To: Kristopher Byrd, Well Construction and Compliance Section Manager
From: Travis Kelly, Well Construction Program Coordinator
Subject: Review of Water Right Application G-19008
Date: September 15, 2020

Application # G- 19008

TO: Water Rights Section Date 9/2/2020
 FROM: Groundwater Section Jen Woody
 Reviewer's Name
 SUBJECT: Application G- 19008 Supersedes review of n/a
 Date of Review(s)

A. GENERAL INFORMATION: Applicant's Name: Beaver Water District County: Tillamook

Figure 3. Stream Depletion

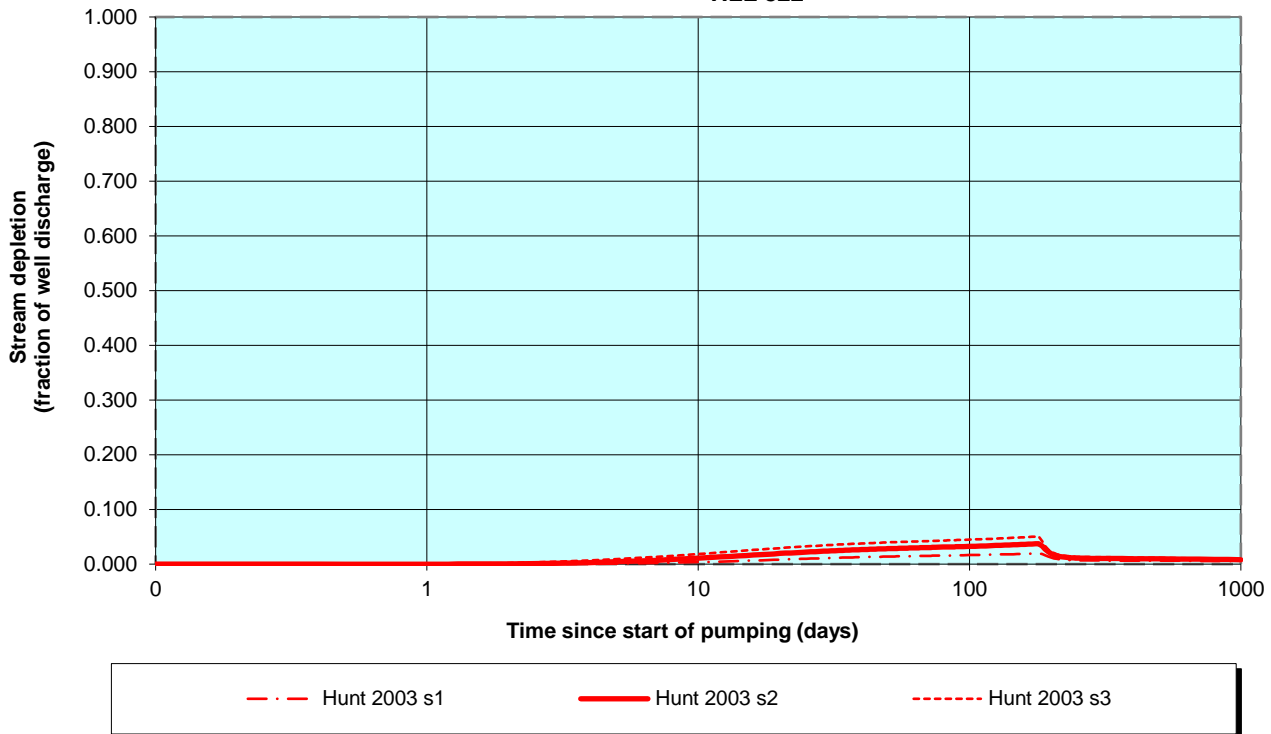
C3a. **690-09-040 (4):** Evaluation of stream impacts for each well that has been determined or assumed to be **hydraulically connected and less than 1 mile** from a surface water (SW) source. Limit evaluation to instream rights and minimum stream flows that are pertinent to that SW source, not lower SW sources to which the stream under evaluation is tributary. Compare the requested rate against the 1% of 80% *natural* flow for the pertinent Water Availability Basin (WAB). If Q is not distributed by well, use full rate for each well. Any checked box indicates the well is assumed to have the potential to cause PSI.

Comments: PSI is triggered because the well is in an unconfined aquifer and located less than 1/4 mile from the Nestucca River.

Rivergreen Properties Well
at
Nestucca Bend

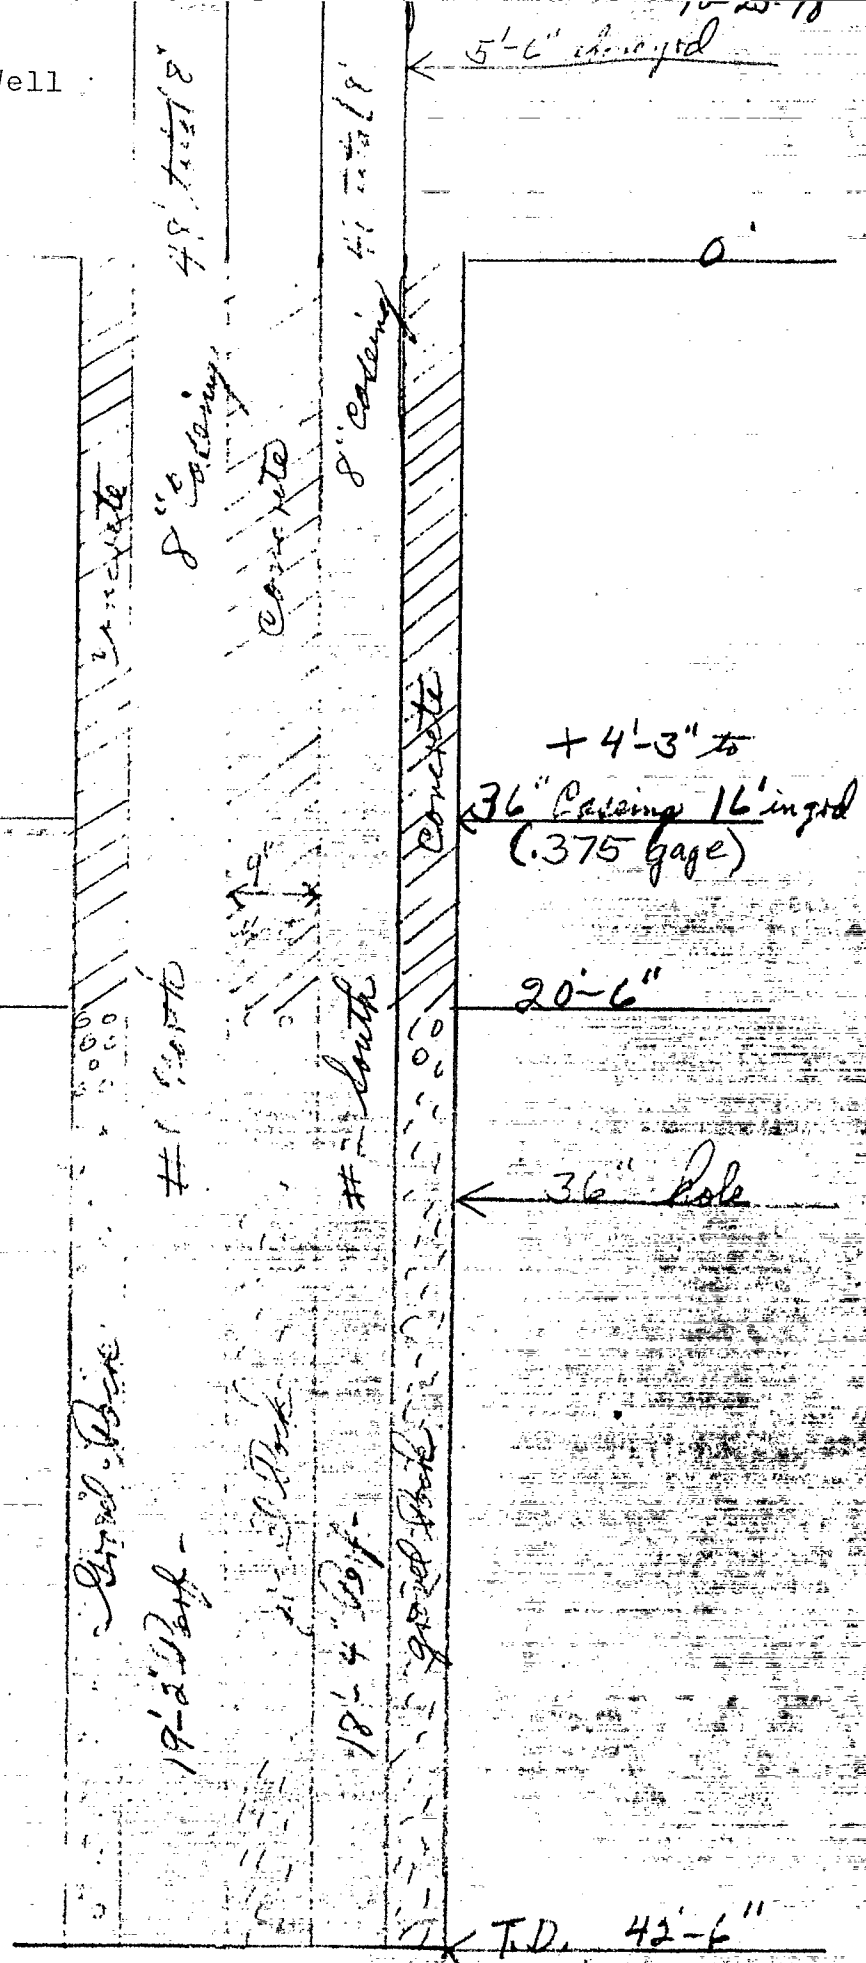
At present the well was drilled to 42' with 36" hole after which we set 2 - 8" casings from a +6' to 42' spaced 9" apart and filled with $\frac{1}{2}$ to $\frac{3}{4}$ " gravel. Ready mix was then poured around the 8" casings and inside the 36" casing.

We then proceeded to pull the 36" casing out, and it came out to 16' (bottom of casing below ground) and stopped. We could not get it to move again, and the cement is set.

We would like to have approval for use to cut the 36" casing off at ground level and bulldoze the dirt up around the casing to 22 or 23' above the bottom of seal as per our letters of October 12, 1978.

W-1105

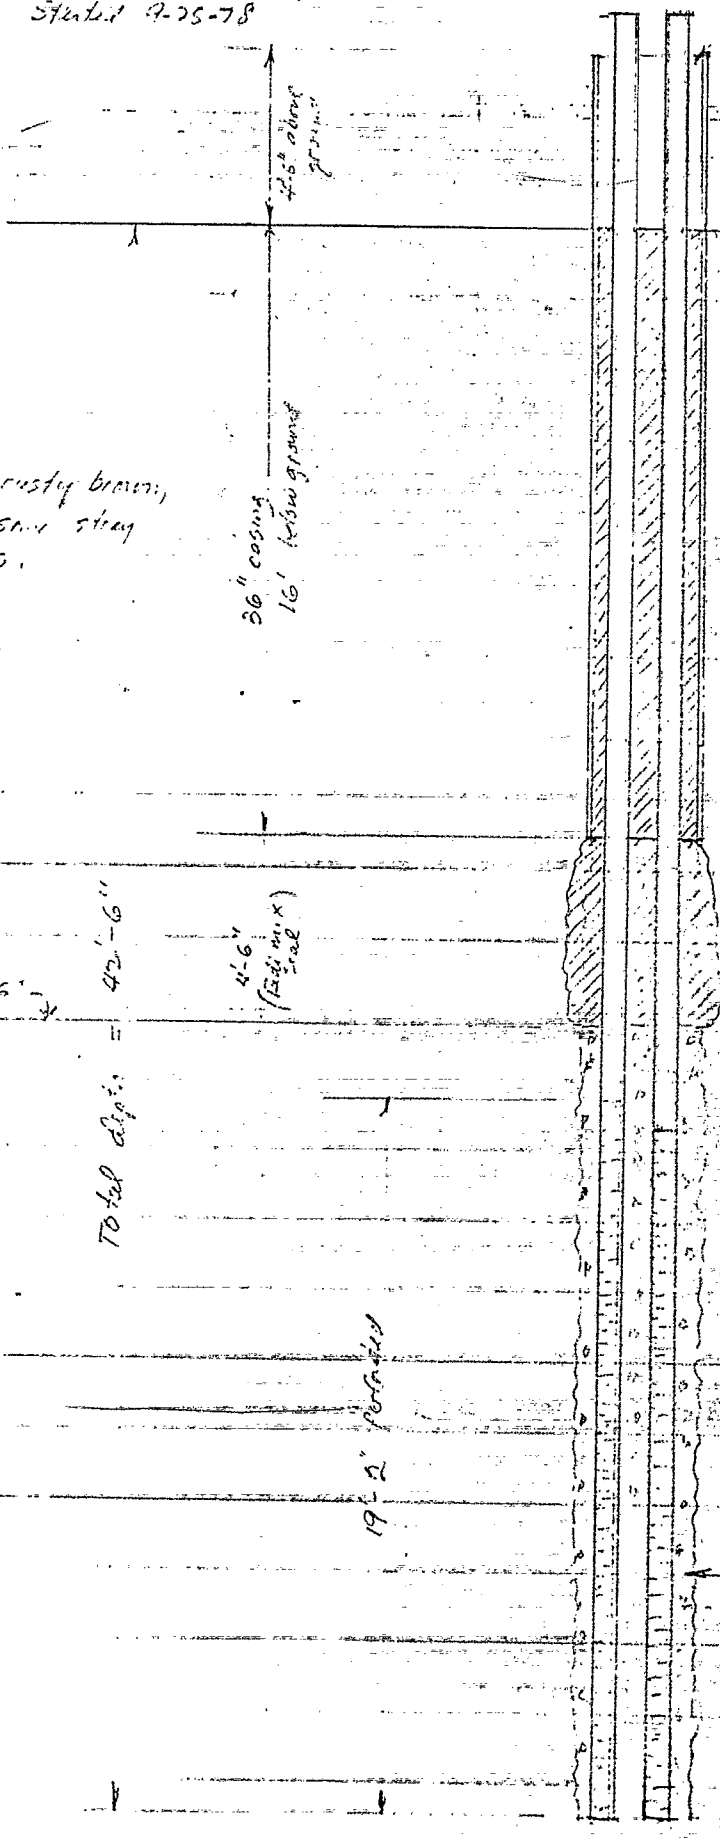
Milo Schnieder, well driller, came in to discuss the status of the gravel-pack well he is putting in at Nestucca Bend. He said that they were not able to completely extract the 36" casing after they installed the redimix seal. He said that after the gravel-pack was placed around the permanent casings (two 8" pipes), the redimix was introduced on top of the gravel-pack (20'-6" depth).

He said the 36" casing was raised 4'-6", but then it stuck. He said that by the time they got the jacks out to the site, the concrete had set up and they were not able to budge the 36" casing. He said that the two 8" permanent casings are 9" apart and are encased in concrete 36" in diameter from the surface down to a depth of 20'-6" below ground level.

I called Bil McCall at the Water Resources Department, and we both agreed that this constituted an effective annular seal.

I drew a sketch of the well construction which is attached.

I discussed this matter with Bill McCall of the Water Resources Board and we both agreed that the redimix concrete seal which completely fills the 36" casing and encases the two 8" well casings, constitutes an effective annular seal.

Accordingly, this construction is hereby approved.

I would recommend that you leave the 36" casing as it is at present (4.5' above existing ground) so that when the area around the well is filled and the well slab is poured, the top of the 36" casing will be above the slab. The two 8" well casings must be 18" above the slab.
